From: Tony Campana
To: [Jim Bertolini](mailto:Jim.Bertolini)
Subject: Re: Status update - 151 S. College (B1913209)
Date: Tuesday, November 12, 2019 2:41:06 PM

Thanks for your patience. Due to the unexpected delay on the survey form, preservation staff reviewed your project with what information we had available about the history of the building. Based on that review, we released the historic review hold on your building permit for this project, with the comment below made:

proposed remodel floor plan
 151 south college avenue
 fort collins, co 80524

front elevation scale: 1/8" = 1'-0"

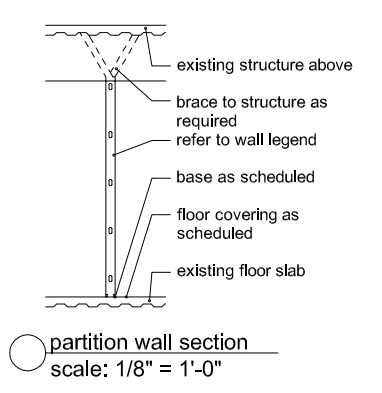
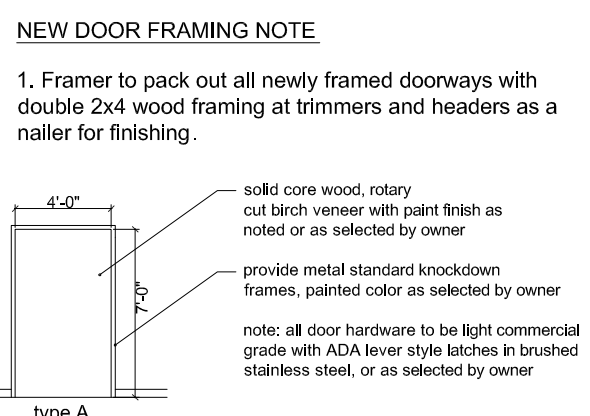
Door and window assemblies at street level appear to be already reconfigured. Proposed alteration should not diminish other remaining features of building that may be historic (pending survey completion). If scope of proposed exterior work needs to expand beyond windows and doors, specifically on the canopy, pillars, or the wall face above, please consult with preservation staff.
